CITY OF CAMBRIDGE, MASSACHUSETTS

PLANNING BOARD

NOTICE OF DECISION

Case Number:	293
Address:	79 JFK Street
Zoning:	Residence C-3 / Harvard-Radcliffe-Lesley Institutional Use Overlay District
Applicant:	President and Fellows of Harvard College, c/o Harvard Planning & Project Management 1350 Massachusetts Avenue, Suite 573, Cambridge, MA 02138
Owner:	President and Fellows of Harvard College Massachusetts Hall, Cambridge, MA 02138
Application Date:	August 5, 2014
Date of Planning Board Public Hearing:	October 7, 2014 and continued to November 25, 2014
Date of Planning Board Decision:	November 25, 2014
Date of Filing Planning Board Decision:	January , 2015
Application:	Request for Project Review Special Permit (Section 19.20) to permit the construction of three institutional building additions and redevelopment of the courtyard at the Harvard Kennedy School Campus.
Decision:	GRANTED, with Conditions

WEST BUILDING ELEVATION - 3'-4" SPACING (ALTERNATE PROPOSAL) 4-5

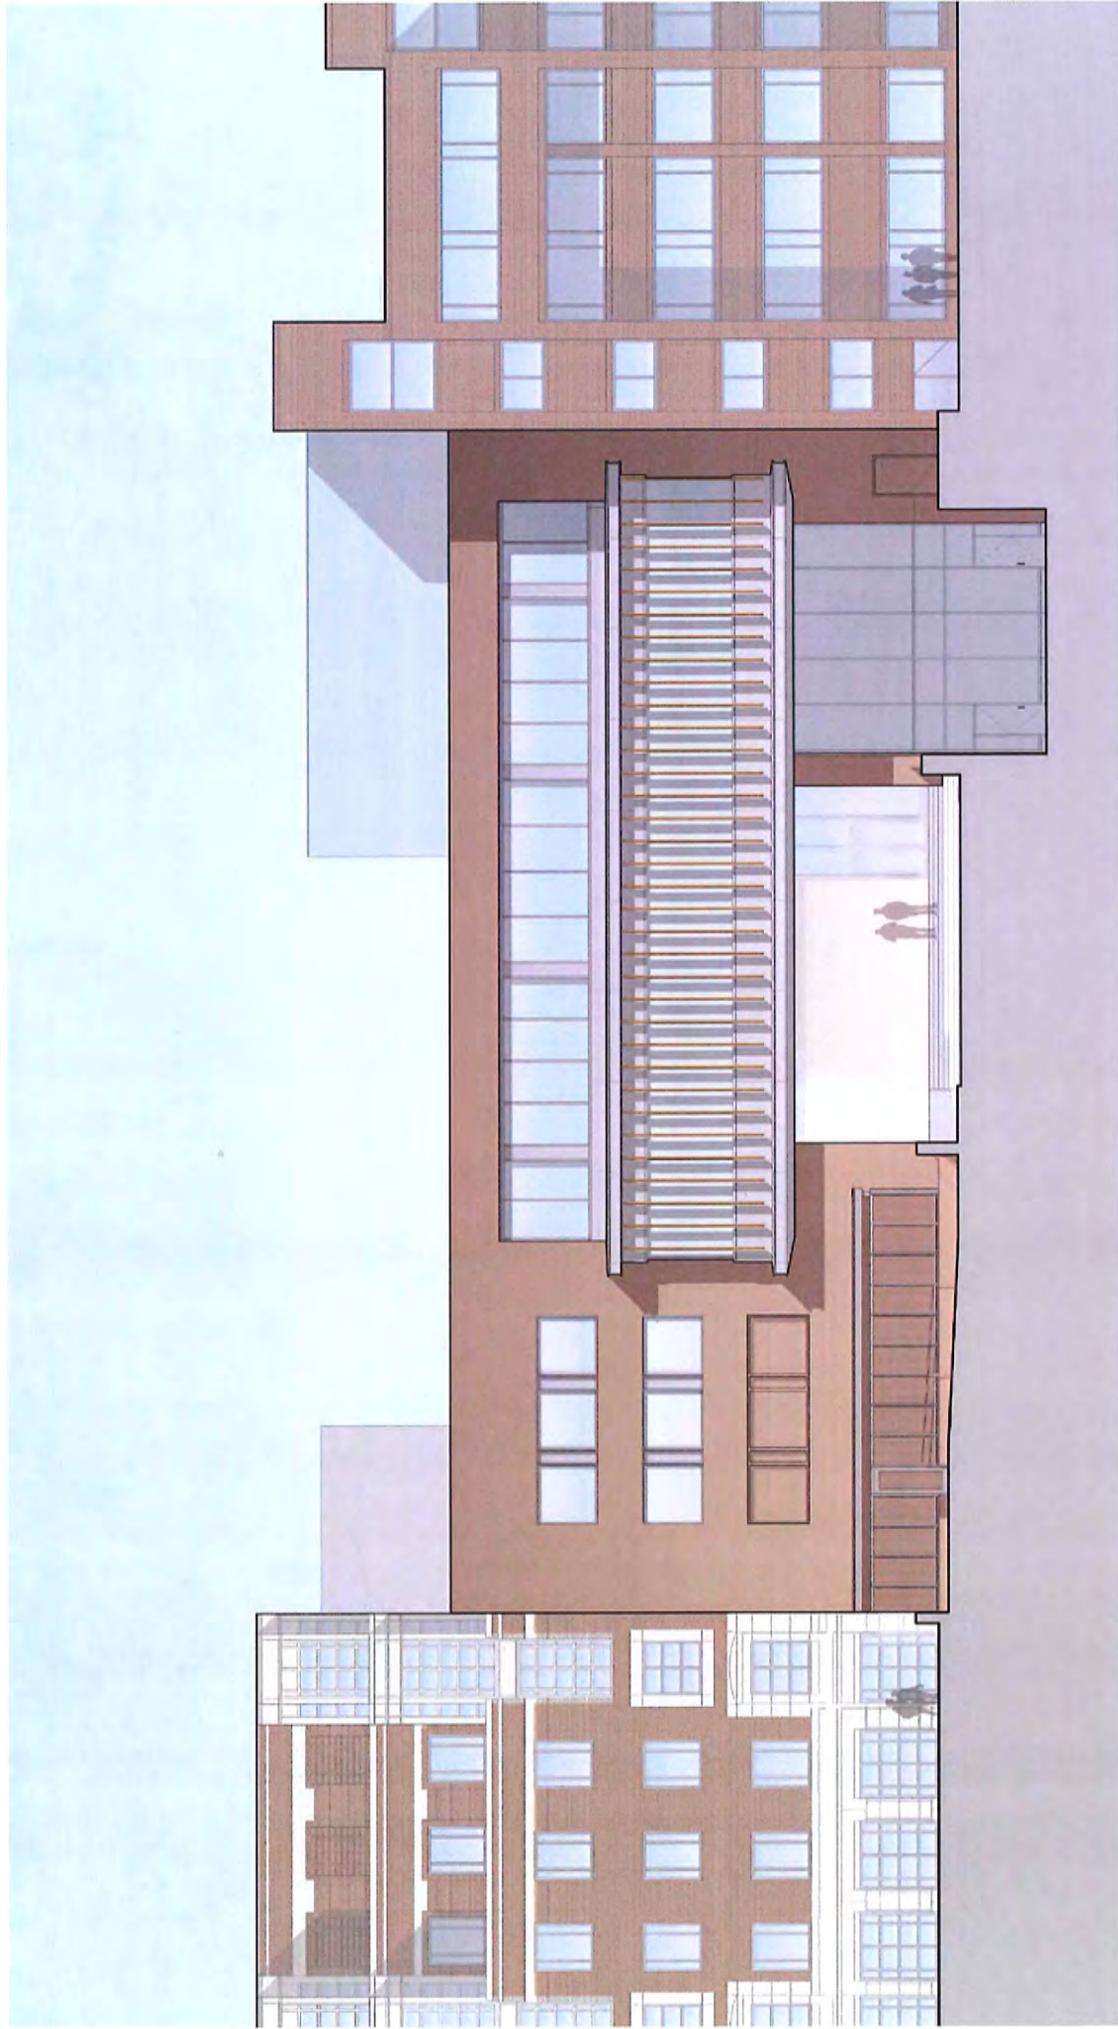
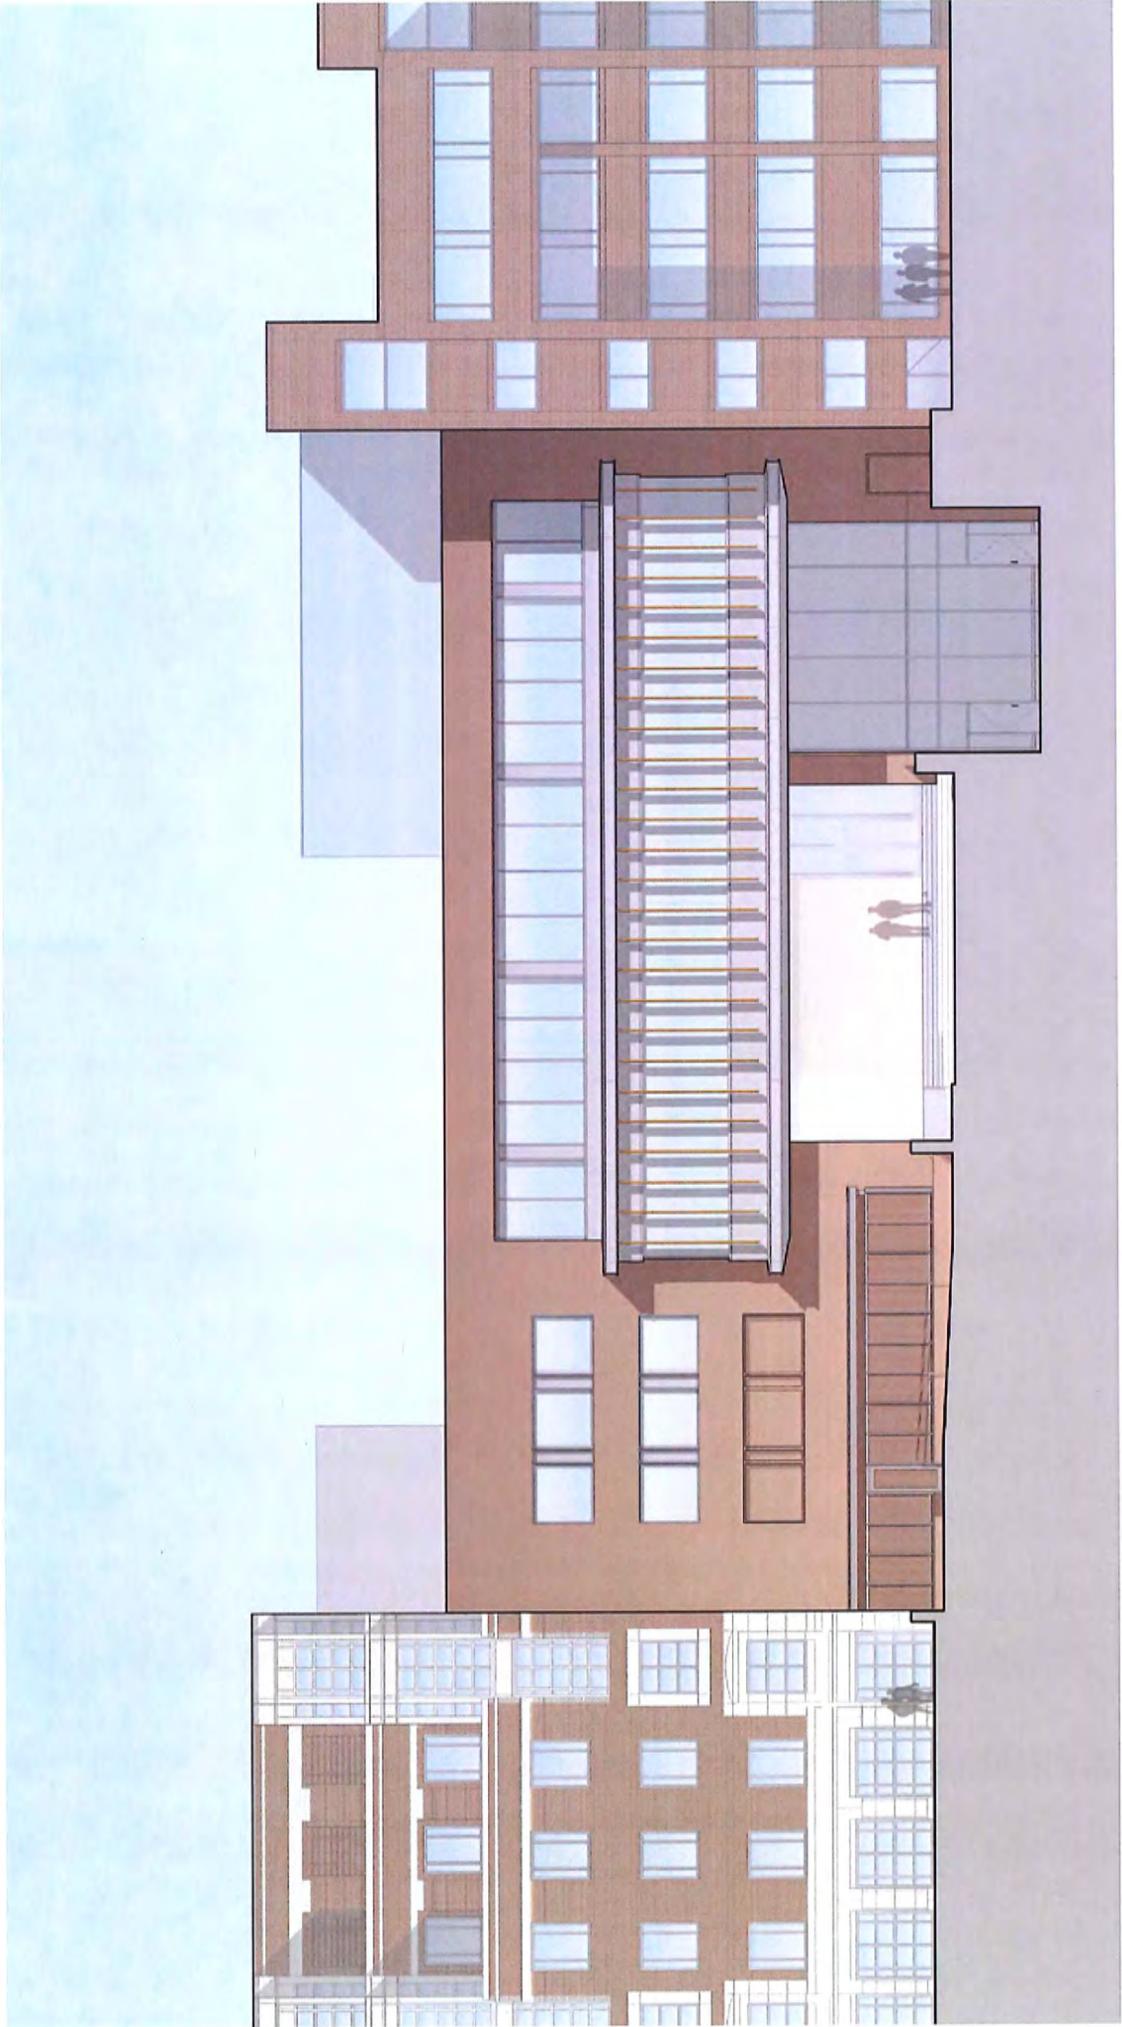
Second, the height of the West Building has been reduced by three feet (See Attachment 4-3). This change is in addition to the previous modification that moves the mechanical penthouse back from the façade a total of 24 feet. These changes will further reduce the visual presence of this addition along the pedestrian walkway. Also, as previously noted, the spacing of the "fins" on the lower level has been expanded to 3' - 4" (from 2' - 6") consistent with the detailing of the Gateway Building (See Attachment 4-5).

ELIOT STREET SECTION AT THE GATEWAY BUILDING

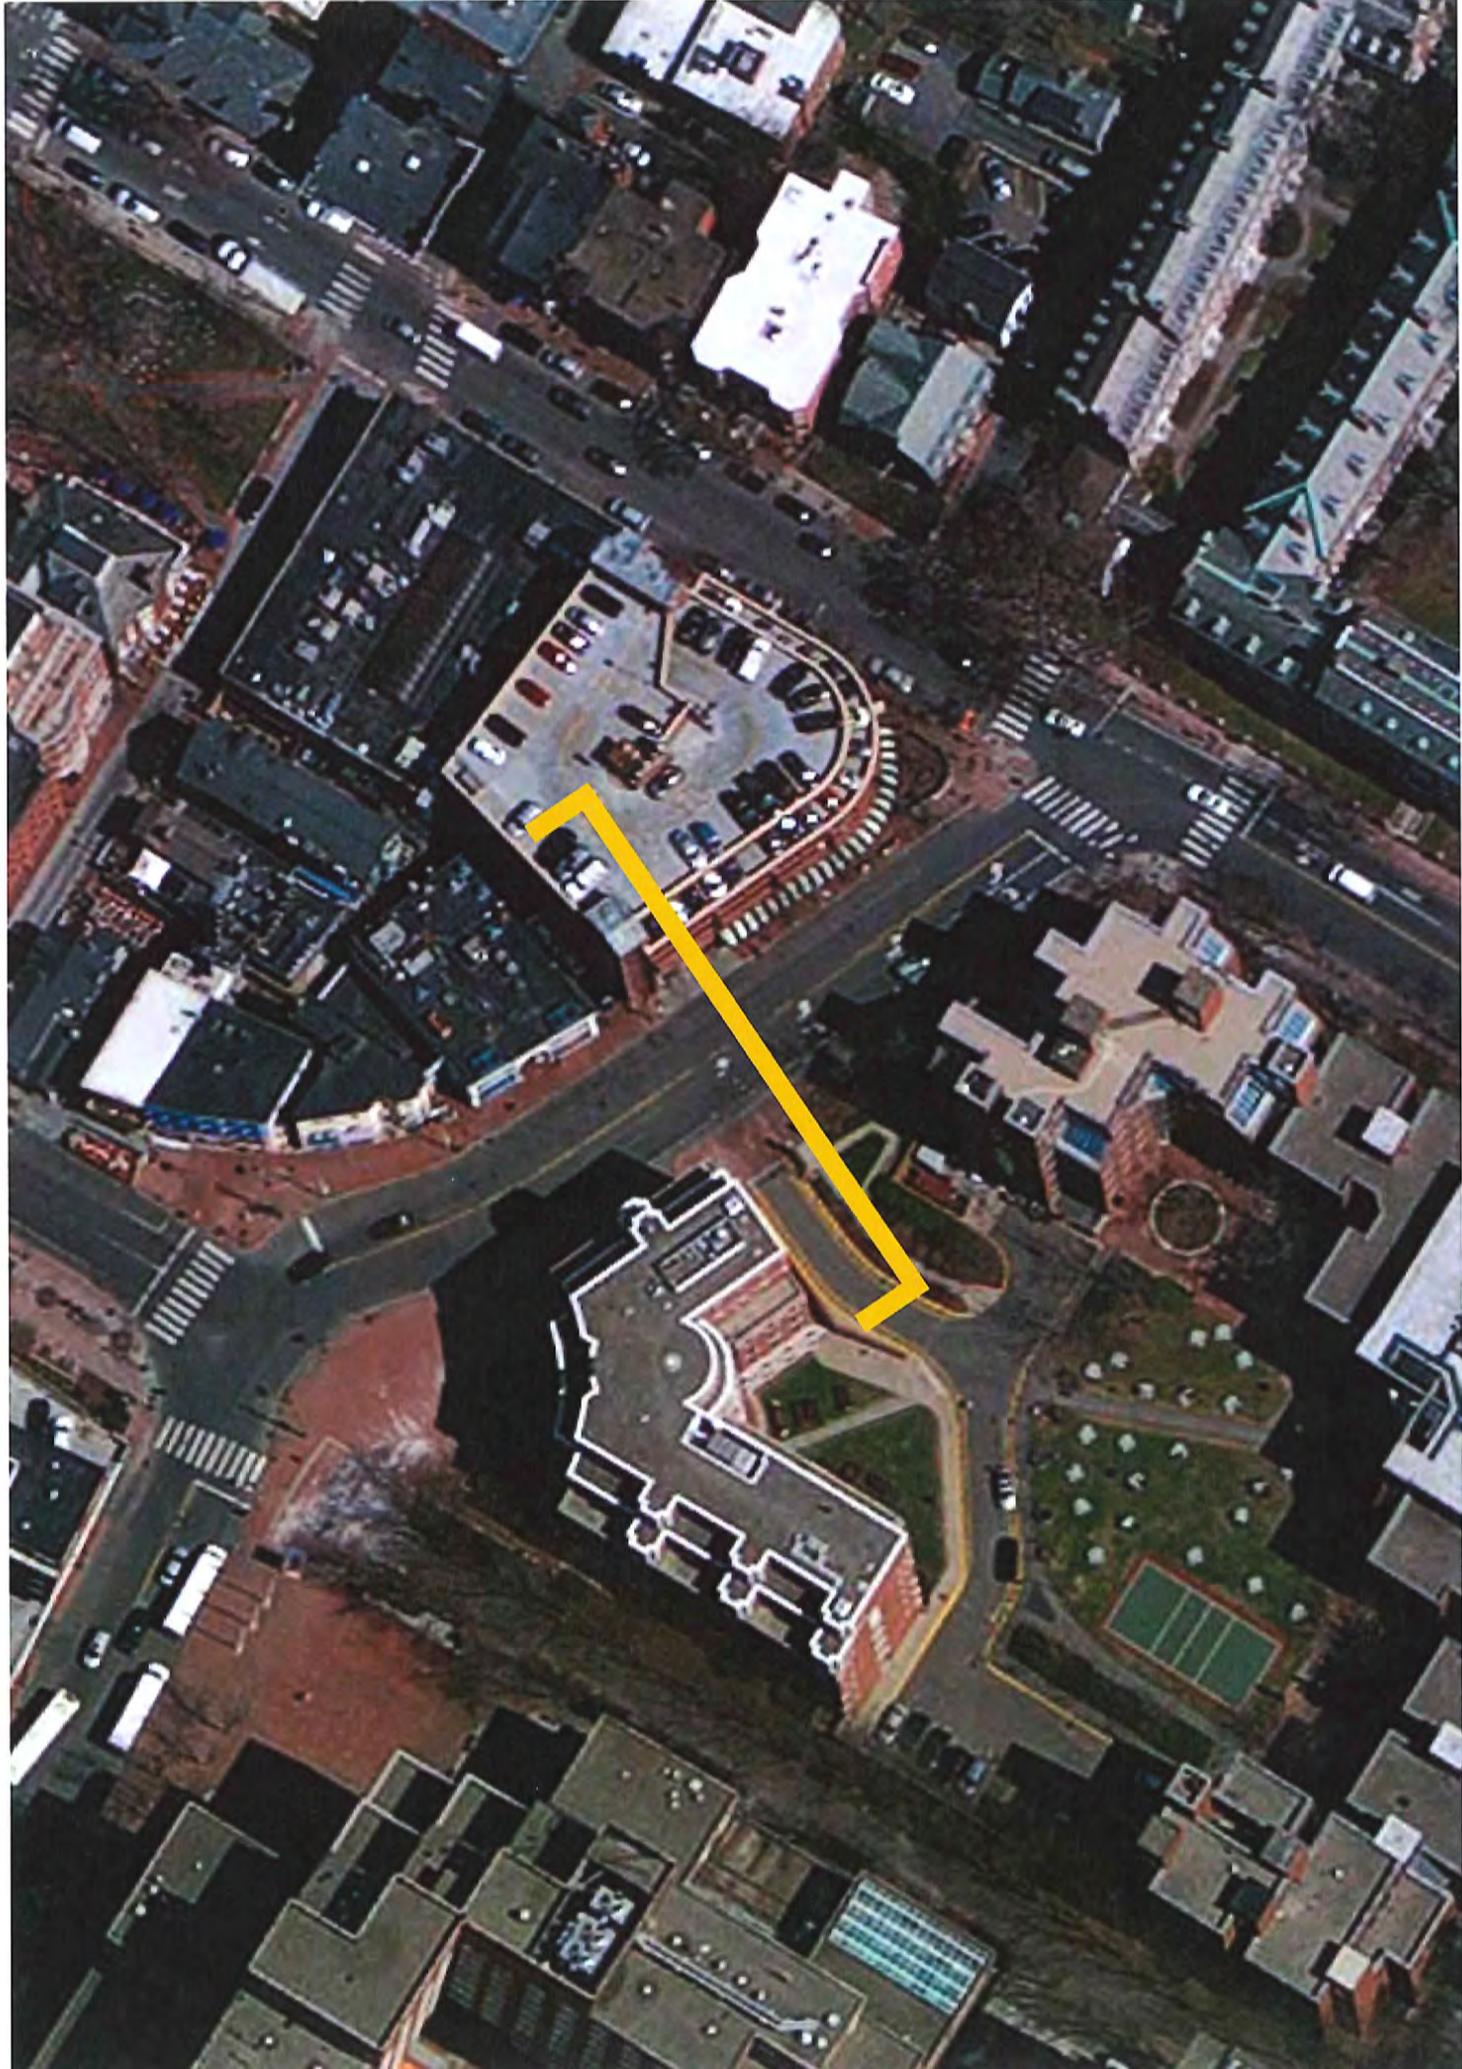
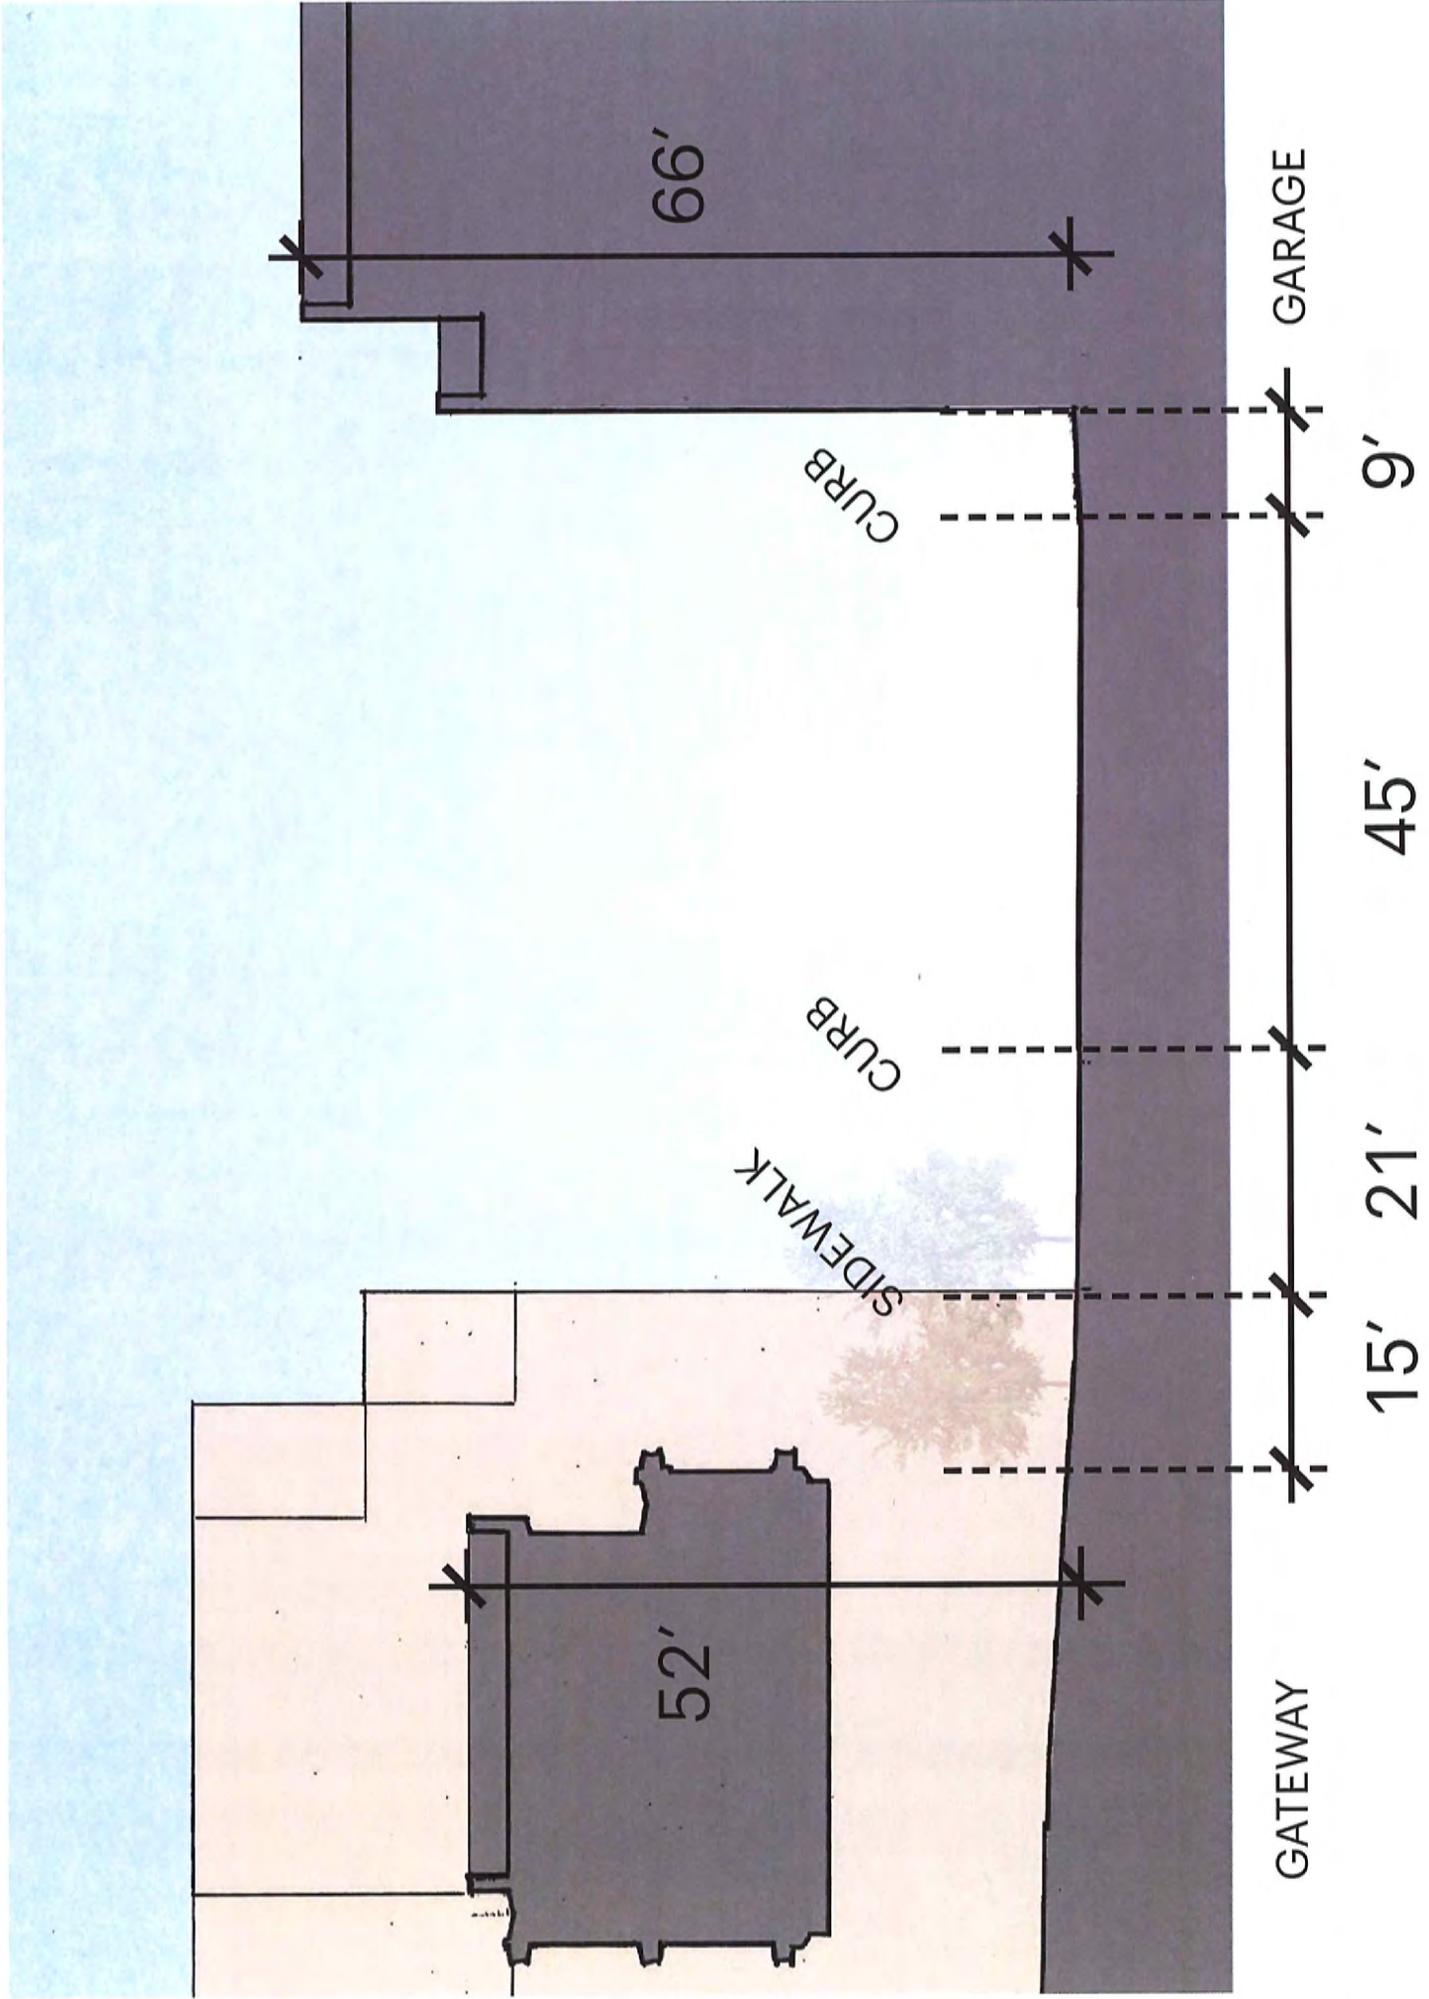
The drawing submitted at the October 28, 2014 public hearing, titled “Eliot Street Section at the Gateway Building” has been revised to correct the indicated dimensions and scale (See Attachment 5).
